Groundwater Application Review Summary Form

Application # G- 18526

Date: July 25, 2017TO: Application: G-18526FROM: GW: Aurora Bouchier
(Reviewer's Name)SUBJECT: Scenic Waterway Interference & General/Local Surface Water
Evaluation for Deschutes Ground Water Study Area

A. GENERAL INFORMATION: Applicant's Name: Crystal Canopy Cultivators LLC County: Deschutes

D1. Well #: 1 Logid: DESC 57132

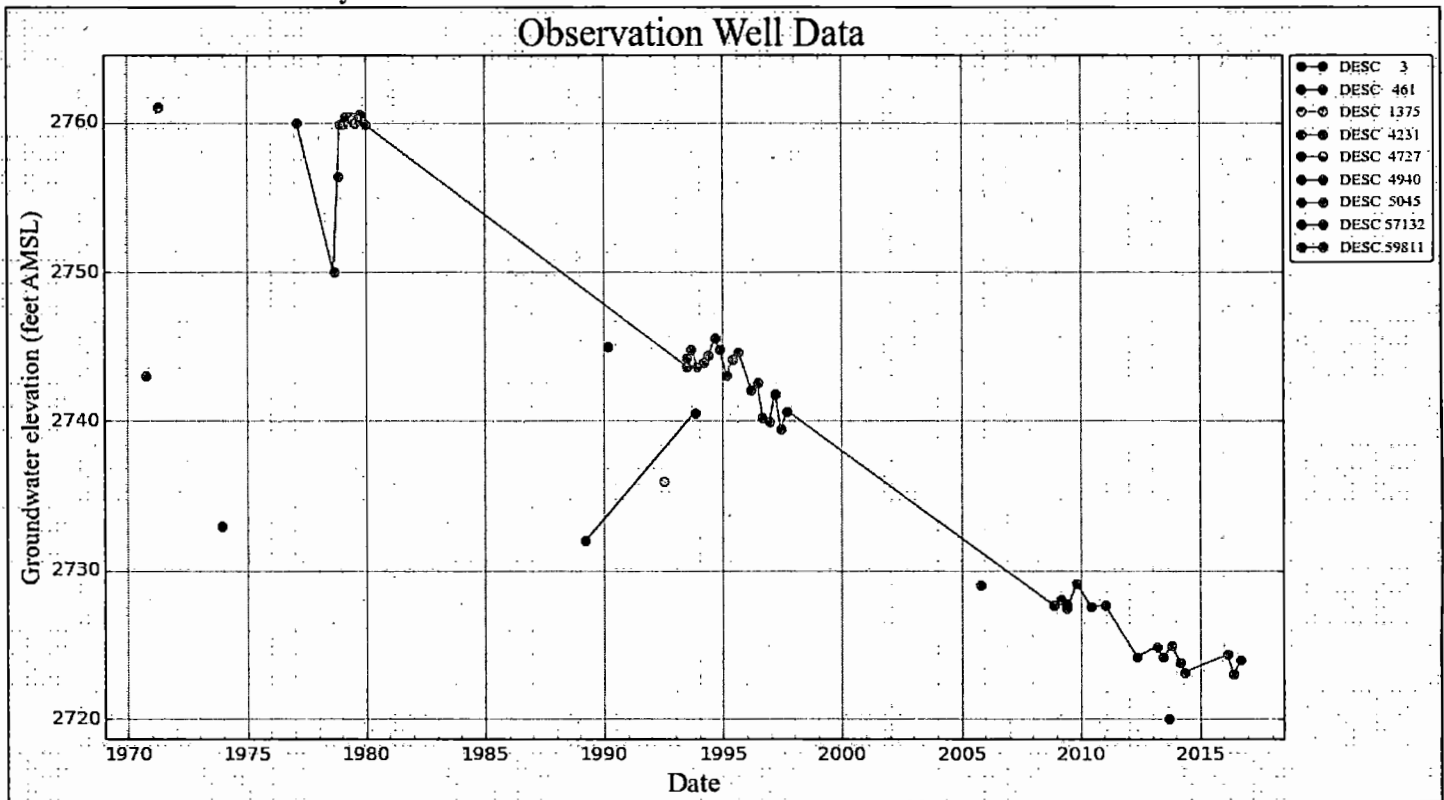
D2. THE WELL does not appear to meet current well construction standards based upon:

- a. review of the well log;
- b. field inspection by _____;
- c. report of CWRE _____;
- d. other: (specify) _____

D3. THE WELL construction deficiency or other comment is described as follows: The well is cased and sealed to 21.5 feet. The water level rose 10 feet above the zone at which it was first encountered. Is this seal sufficient?

D4. Route to the Well Construction and Compliance Section for a review of existing well construction.
